City of San Antonio
Department of Planning and Development Services

Re: **Luckey Ranch**

MDP # 010-09

#010-09
LUCKEY RANCH
MASTER DEVELOPMENT PLAN

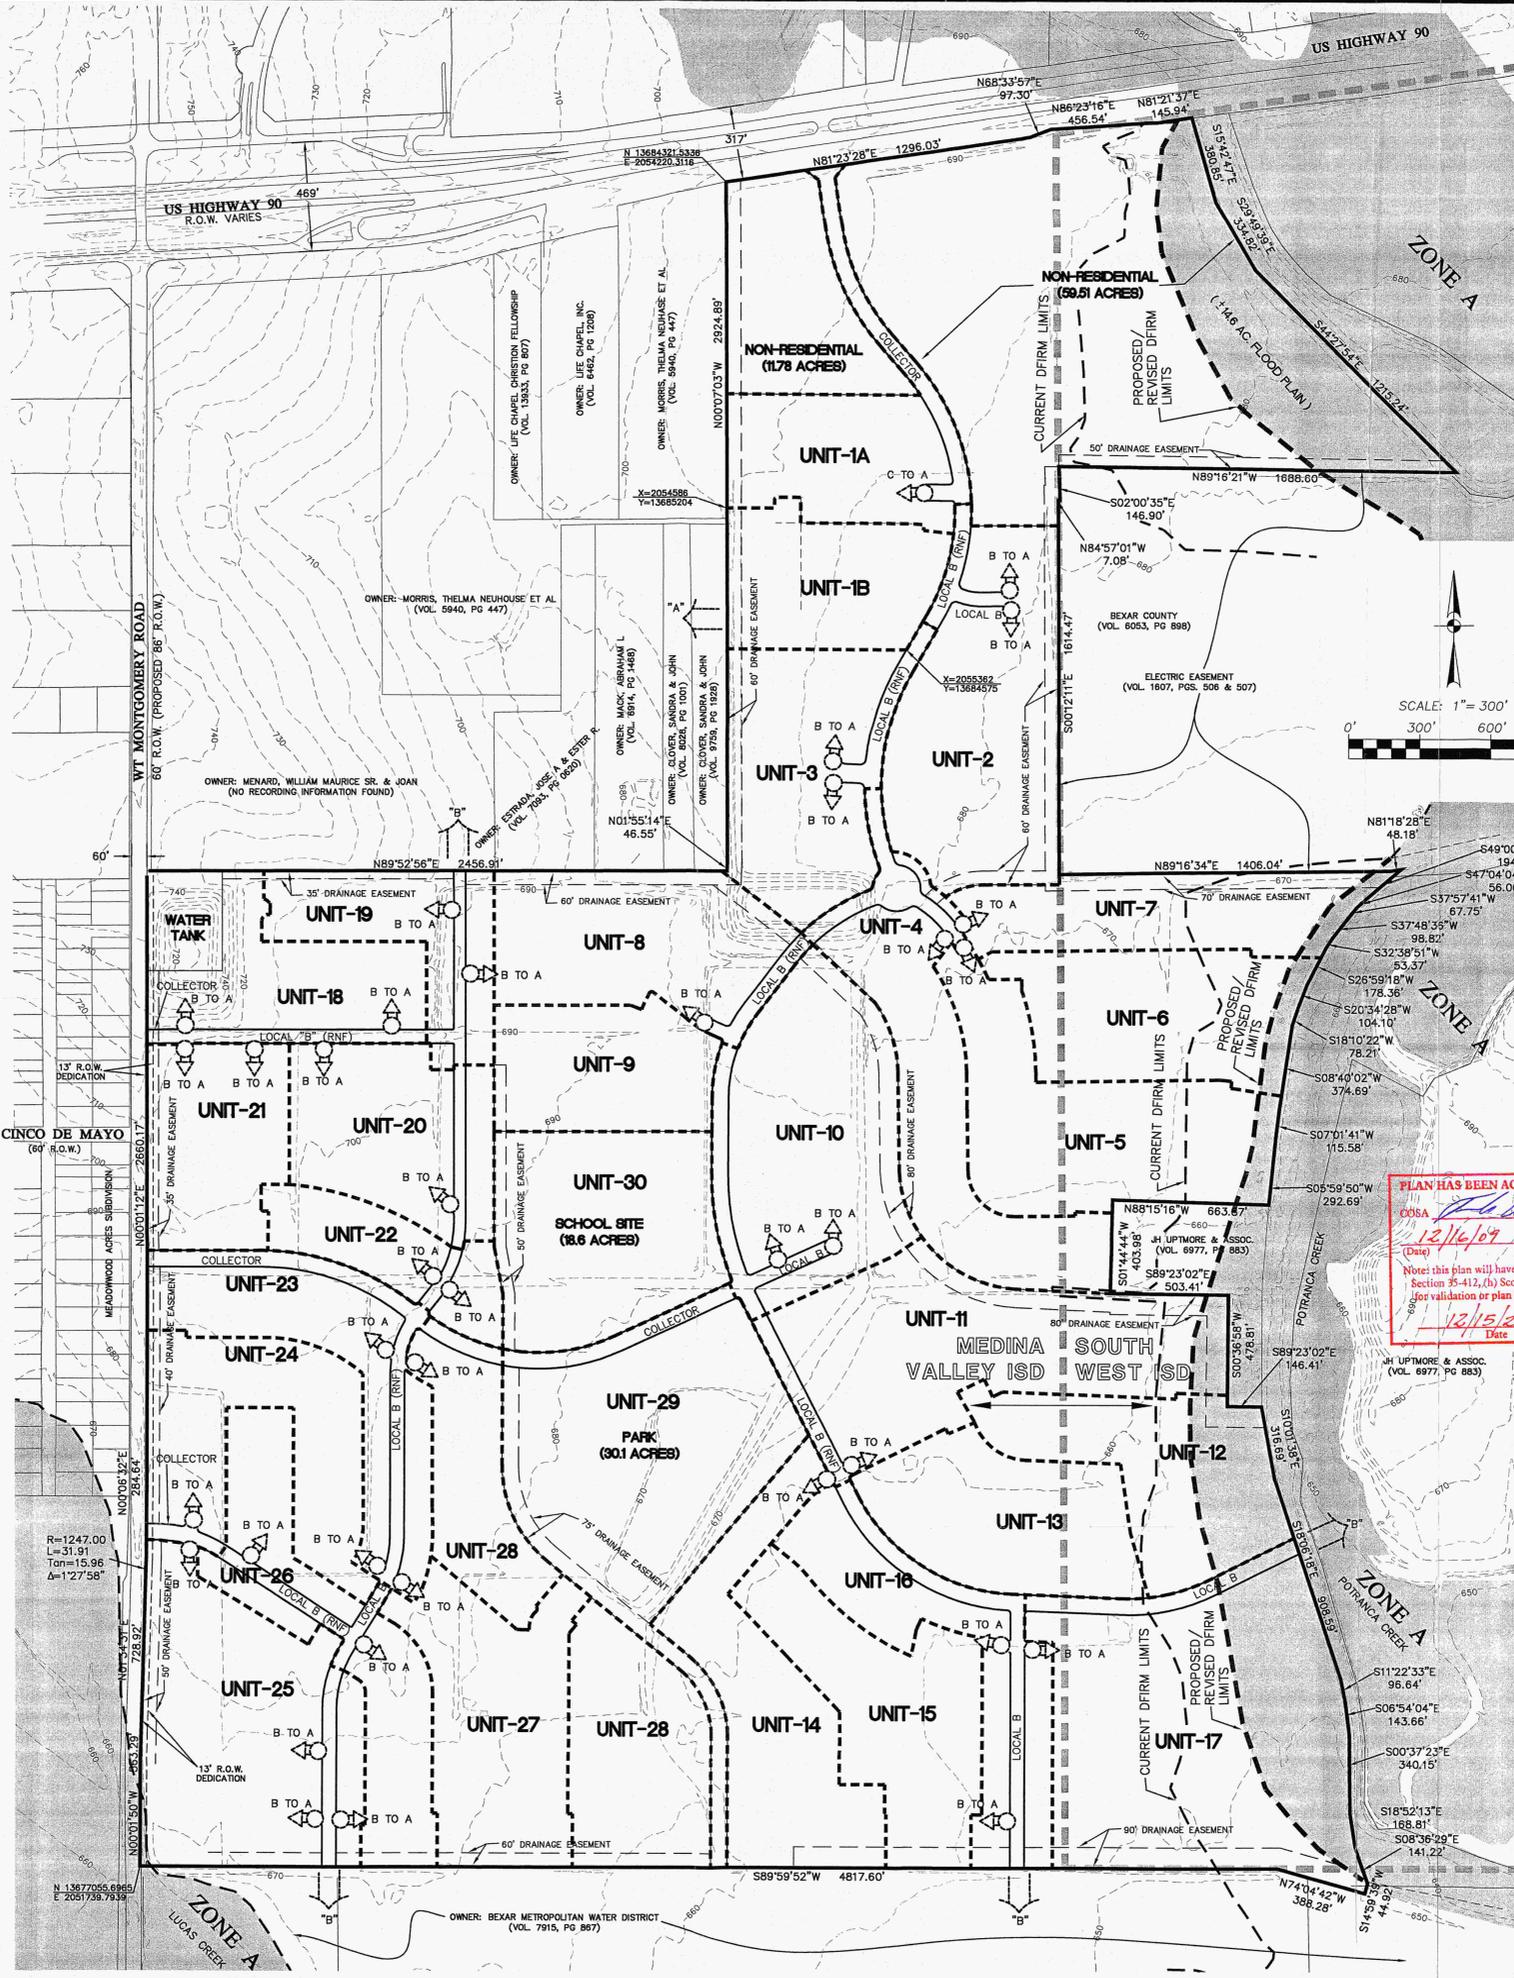
The Development Review Committee has reviewed **Luckey Ranch** Master Development Plan, or **MDP 010-09**. Enclosed is an accepted and signed copy of the MDP for your files. However, please note the following conditions:

It will be expected that all of the property depicted in the Master Development Plan including but not limited to floodplains, drainage areas, and open space shall be platted. All platting shall comply with the Unified Development Code (UDC), the City's Master Plan, Major Thoroughfare Plan, and all applicable regulations for the City of San Antonio.

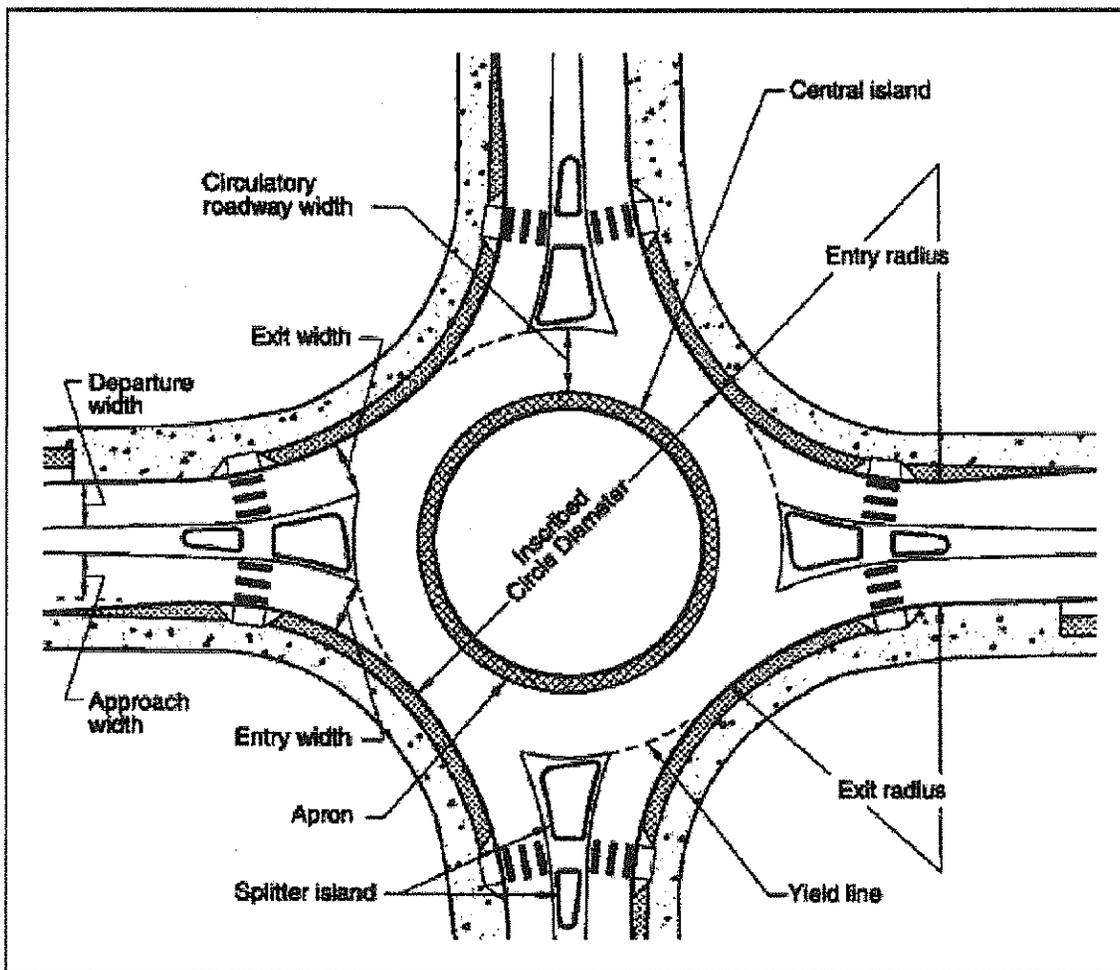
- All roadways shall follow Table 506-7, Functional Classification System Description and shall comply with UDC 35-502(a)(9).
- All access roadways shall provide clear sight distance on all existing and proposed roadways in order to provide adequate obstruction free viewing distances for approaching traffic. All signage, landscaping, and improvements shall be selected and located so as to not block these clear sight distance areas. AASHTO Geometric Design of Highway and Streets latest edition.

- **The traffic circle shall be designed and reviewed in accordance with the FHWA Roundabout design manual (See chapter 6 <http://www.tfhrc.gov/safety/00068.htm>).**

- The Local "B" road serving Units 5 and 6 shall be a full 60' ROW with 40' of pavement for two complete blocks prior to transitioning to a Local "A".
- The frontage road intersections along Montgomery Road will require mitigation for traffic signals (when warranted and approved by Bexar County Traffic, Public Works – Traffic and TxDOT) as per UDC 35-502, (7) Limitations on Traffic Impact Analysis, C. All street locations are identified in the approved Master Development Plan. Traffic signals shall

be warranted and approved by Bexar County Traffic, Public Works – Traffic and TxDOT. All traffic shall be coordinated along the proposed street network.

All streets and driveways shall follow UDC 35-506 and the street network shall be planned in order to provide safe and efficient movement of traffic to and from, within and past, the proposed development, while minimizing the impact to non-site trips. UDC 35-506 will be implemented at the time of platting.

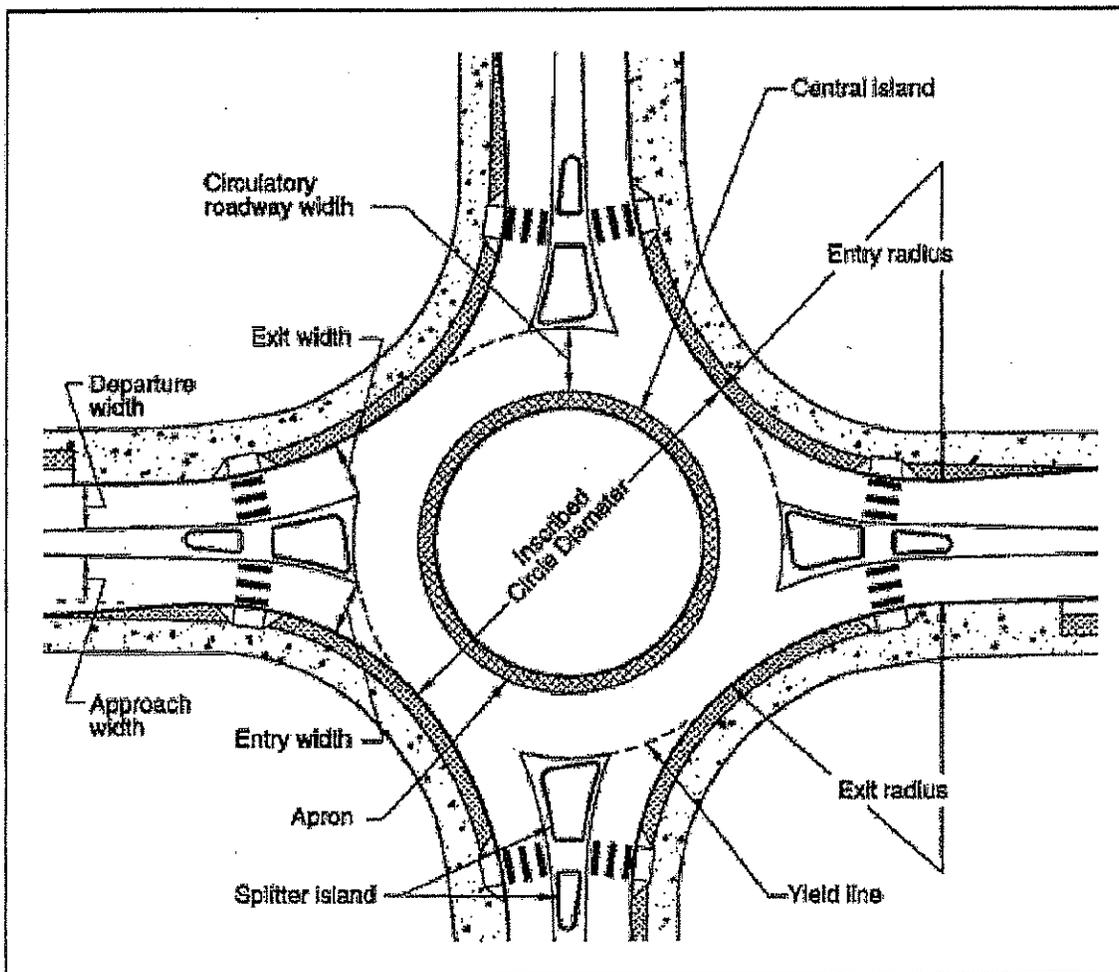
- All roadways shall follow Table 506-7, Functional Classification System Description and shall comply with UDC 35-502(a)(9).
- All access roadways shall provide clear sight distance on all existing and proposed roadways in order to provide adequate obstruction free viewing distances for approaching traffic. All signage, landscaping, and improvements shall be selected and located so as to not block these clear sight distance areas. AASHTO Geometric Design of Highway and Streets latest edition.

- **The traffic circle shall be designed and reviewed in accordance with the FHWA Roundabout design manual (See chapter 6 <http://www.tfhrc.gov/safety/00068.htm>).**

- The Local "B" road serving Units 5 and 6 shall be a full 60' ROW with 40' of pavement for two complete blocks prior to transitioning to a Local "A".
- The frontage road intersections along Montgomery Road will require mitigation for traffic signals (when warranted and approved by Bexar County Traffic, Public Works – Traffic and TxDOT) as per UDC 35-502, (7) Limitations on Traffic Impact Analysis, C. All street locations are identified in the approved Master Development Plan. Traffic signals shall

be warranted and approved by Bexar County Traffic, Public Works – Traffic and TxDOT.
All traffic shall be coordinated along the proposed street network.

All streets and driveways shall follow UDC 35-506 and the street network shall be planned in order to provide safe and efficient movement of traffic to and from, within and past, the proposed development, while minimizing the impact to non-site trips. UDC 35-506 will be implemented at the time of platting.
